# TOWN OF HUDSON

### PUBLIC MEETING TOWN OF HUDSON, NH MARCH 29, 2017

**PLAN UNDER REVIEW ENTITLED:** Heilind Electronics 18 Industrial Drive, Hudson, NH, Map 161/Lot 37, prepared by Maynard & Paquette Engineering Associates, LLC, dated: 20 JUL 2016, last revised 9 MAR 17, consisting of Sheets 1 – 4 and Notes 1 – 20 (plans attached hereto).

**PLAN UNDER REVIEW ENTITLED:** Mac Thompson Site Plan, 48 Lowell Road, Tax Map 190, Lot 191, prepared by Benchmark Engineering, Inc., Londonderry, NH, dated: 12 DE 16, last revised 20 MAR 17, consisting of Sheets 1 – 9 and Notes 1 – 27 (Sheet 3 of 9) (plans attached hereto).

SCALE: 1"=30' SHEET 3 OF 9 DECEMBER 12, 2016

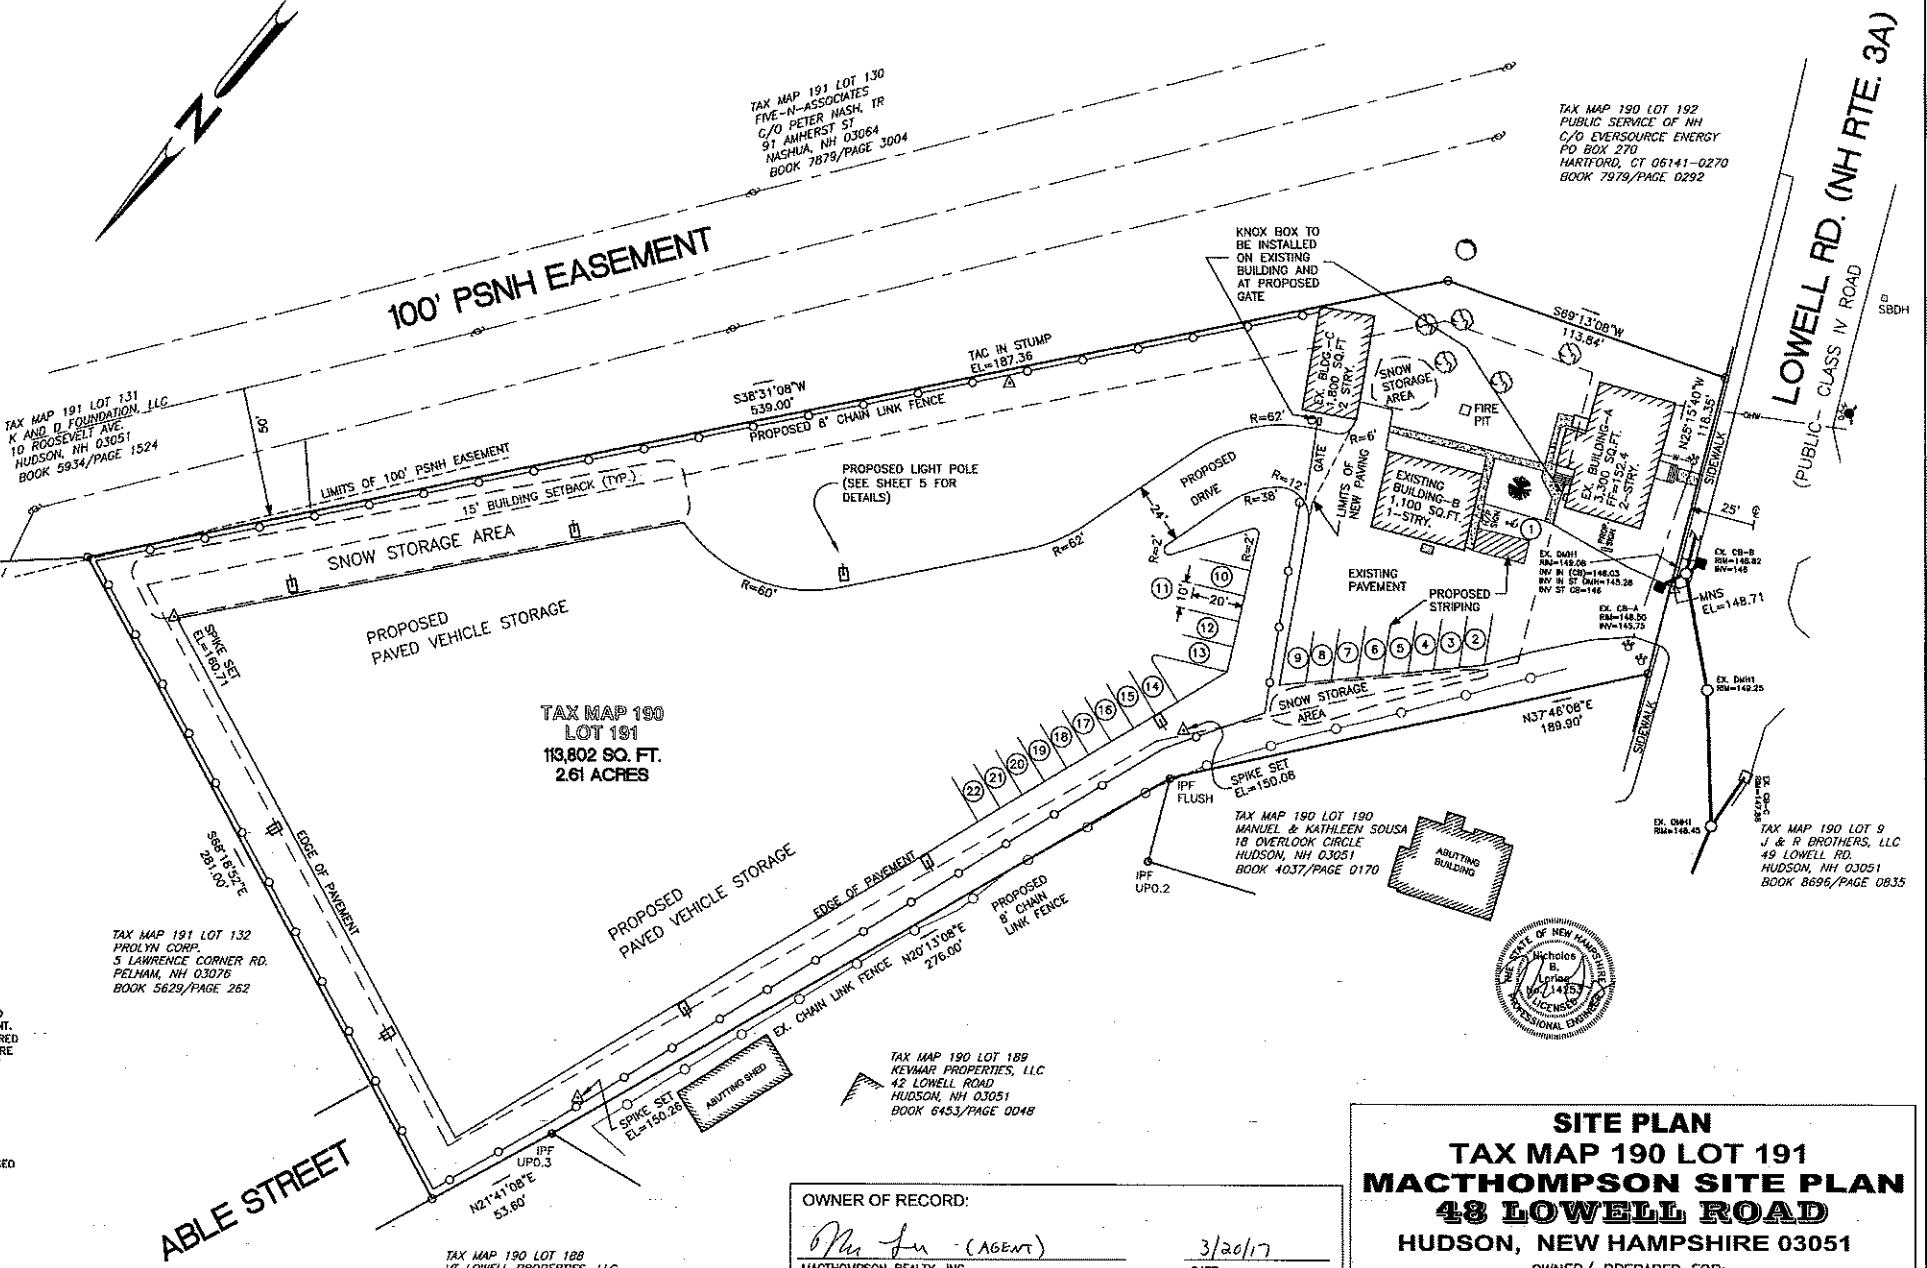
**The building and parking are existing . There is limited space between the existing building and the required pavement setback. We are requesting a waiver to reduce the aisle width from 24' to 22'. This reduction in isle width is in front of parking spaces #2 and #3 (see site plan sheet-3) only.**

- h. Spot shots have been provided at the existing sidewalk along with the required ADA note on sheet-3 (Note #25). The existing sidewalk along Lowell Road was recently constructed and is within the town right of way. We are proposing no work within the Town right-of-way or to the sidewalk.

- c. The limits of new paving have been identified on sheet-3; in the area of the proposed gate.
- 3. Utility Design/Conflicts**
  - a. Utility services between buildings is subsurface and no plans of record shown their locations. All Utilities have been shown and we are unable to provide further information without excavation.

- c. Electrical connections to sight lighting have been added to sheet-3.
  - d. A note has been added to sheet-4 Note #2, to verify the existing water line elevation prior to construction of the drainage improvements.

- a. The Town Zoning determination indicated that the existing lot is non-conforming with regards to frontage. It is our understanding that since the lot is existing and has a commercial use, no variance is required. Note #11 on sheet-3 has been updated to show the lots existing frontage.
- b. A chain link fence detail was added to sheet-9.
- c. No vehicle repair or service will take place on site.
- d. Note # 26 has been added to sheet-3 indicating the intended hours of operation.
- e. The front setback line has been revised.
- f. No action required.
- g. The proposed sign has been moved to 50% of the front setback or 25 feet.
- h. No action required.

**GRADING, DRAINAGE, UTILITY  
& EROSION CONTROL PLAN  
TAX MAP 190 LOT 191  
MACTHOMPSON SITE PLAN  
48 LOWELL ROAD  
HUDSON, NEW HAMPSHIRE 03051**

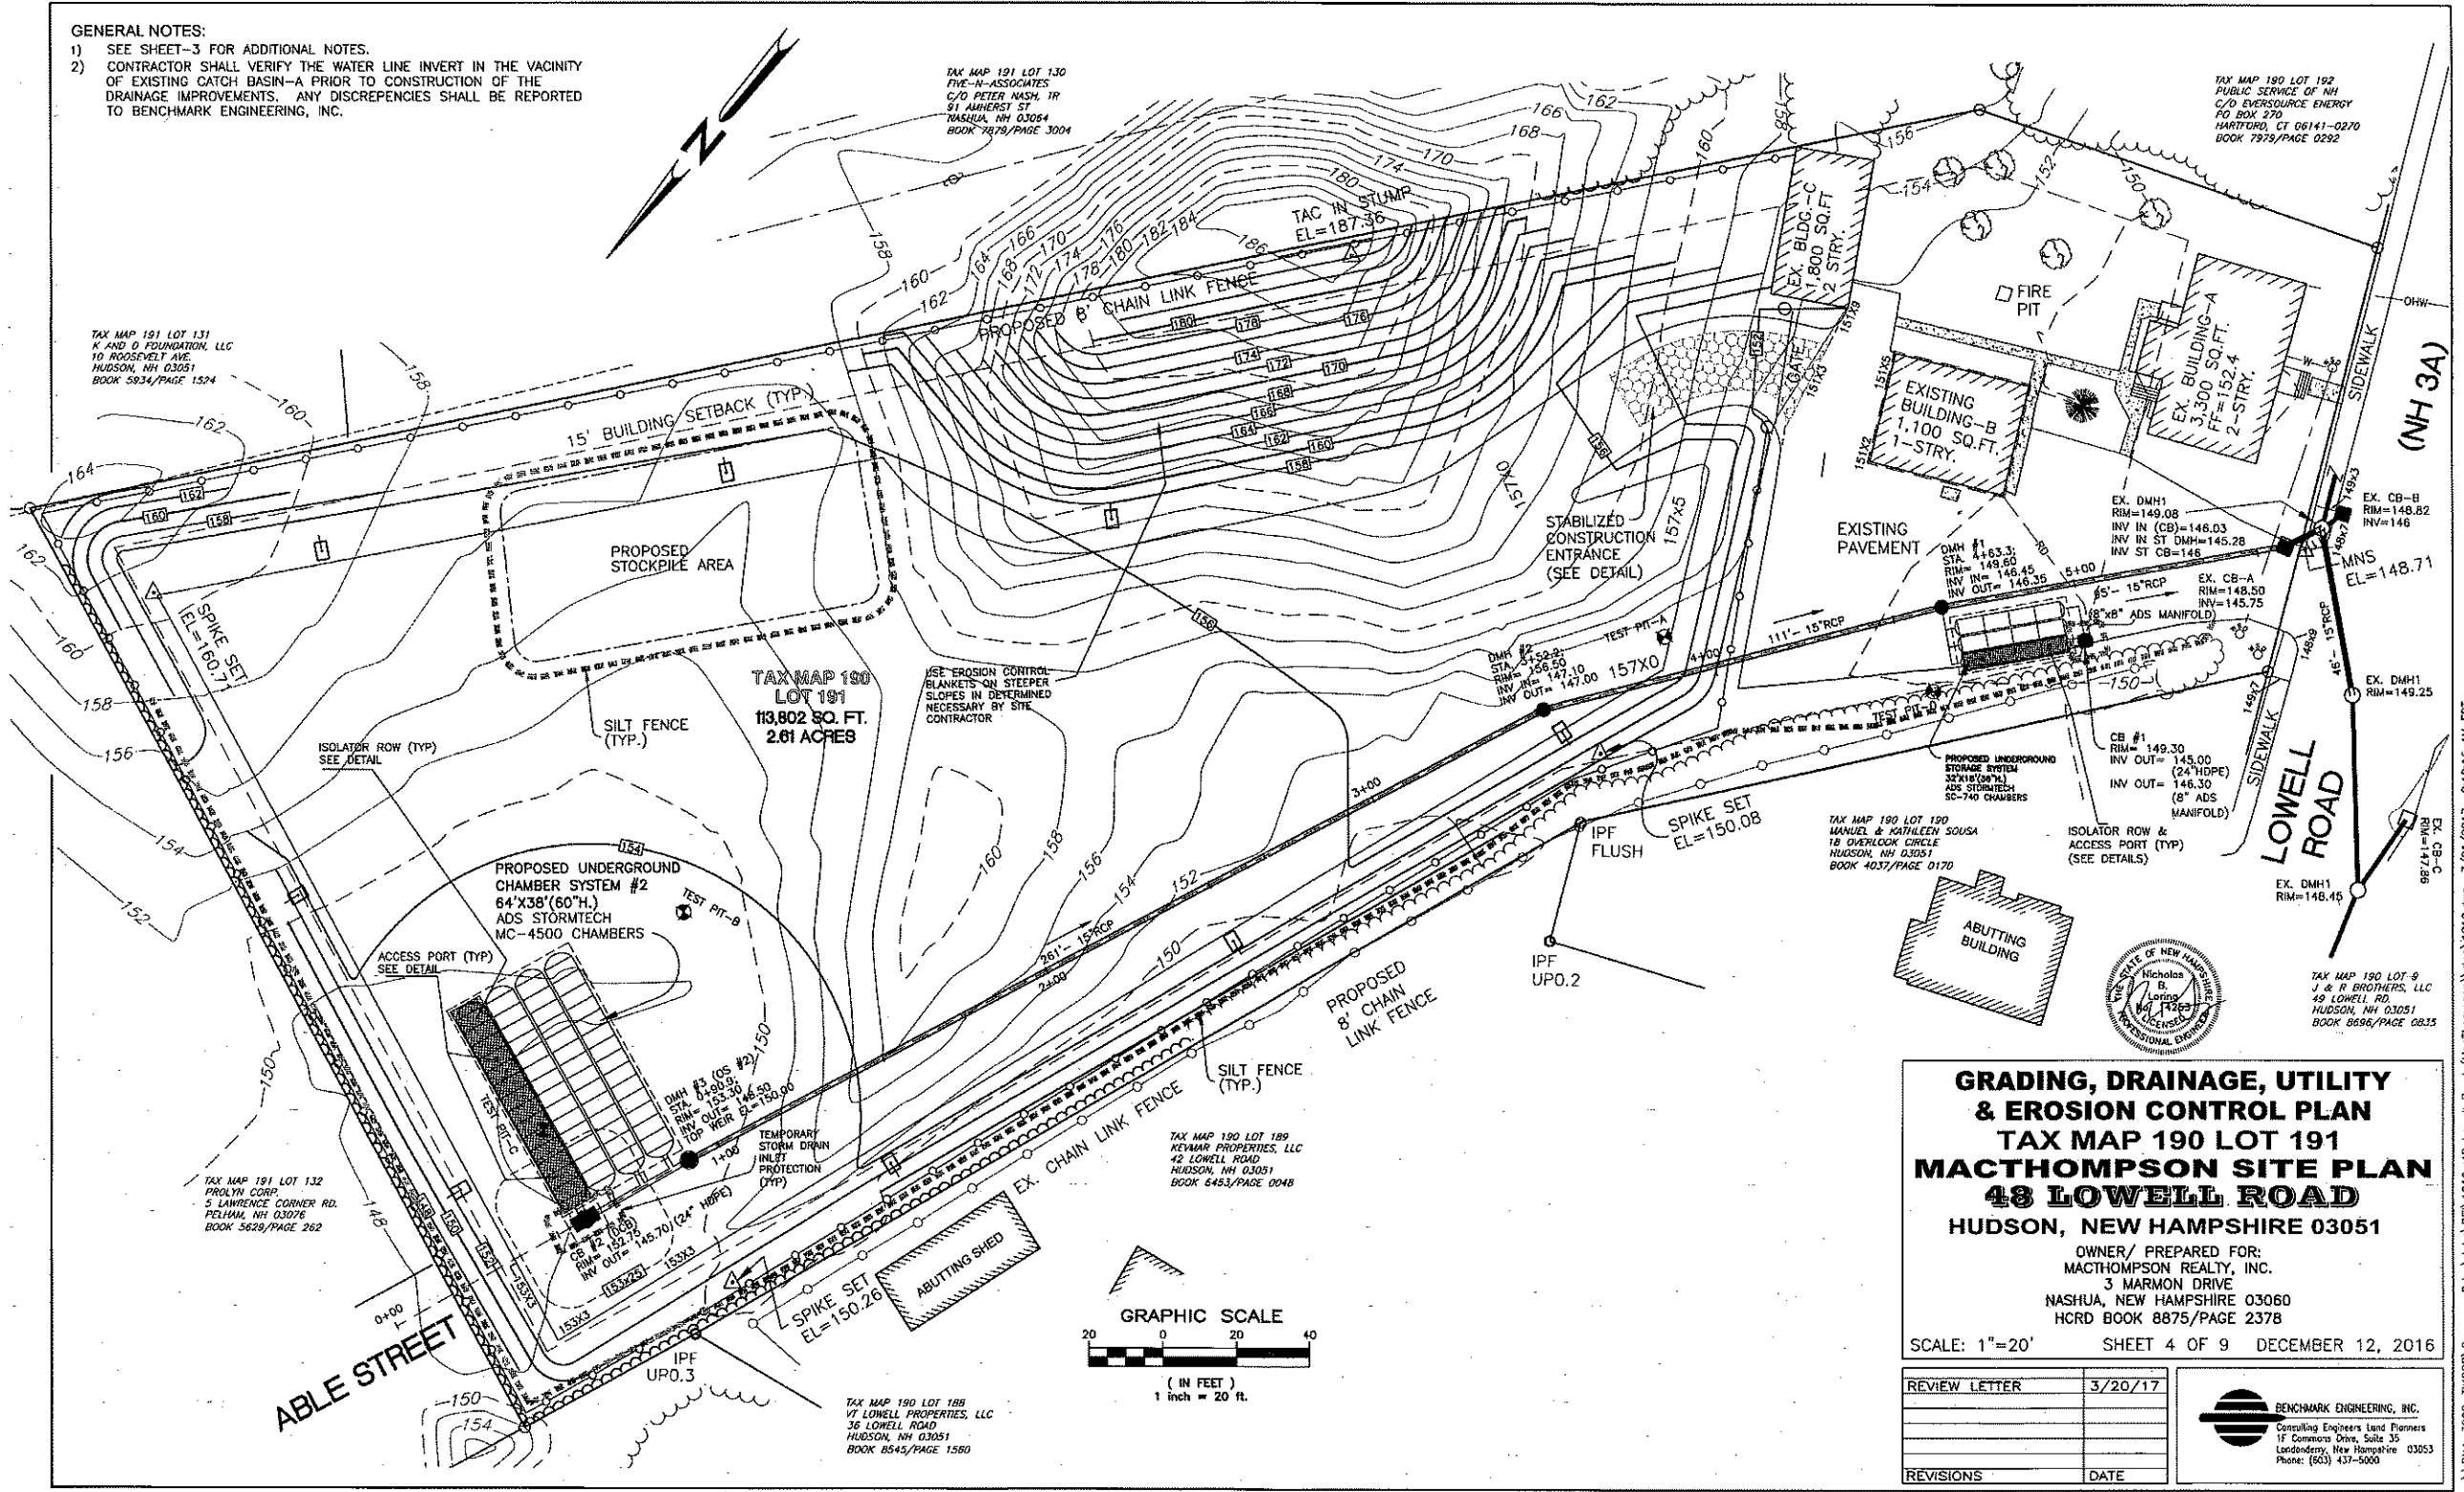
- c. HR 290-4.C. The applicant should illustrate the appropriate erosion control practice locations listed on Detail Sheet 9 in a plan view, as well as show any other required erosion control practices (construction entrance, inlet protection, etc.).

- a. The applicant should coordinate the Pavement Detail with the Typical Drain Trench Detail as they differ in pavement and subbase depths.
- b. The applicant has not shown any dumpsters, pads or enclosures proposed for the site. The applicant should clarify proposed trash disposal practices.
- c. The applicant should correct the graphic scale on Sheet #4.

- c. Sheet-4 has been revised to show erosion control practices. This plan shows the proposed silt fence, catch basin inlet protection and erosion control blankets.

- a. A stabilized construction entrance has been added to the plan set on sheet-4 and a detail on sheet-8.
- b. A stockpile area has been shown on sheet-4 along with appropriate erosion control measures.
- c. Note #27 has been added to sheet-3 regarding proper disposal of stumps.

- a. The Pavement Detail and Typical Drain Trench detail have been revised to match pavement and gravel depths.
- b. At this time we do not anticipate a need for a dumpster. The trash will be stored in smaller containers and appropriately disposed of by the owner.
- c. The graphic scale on sheet-4 has been revised.
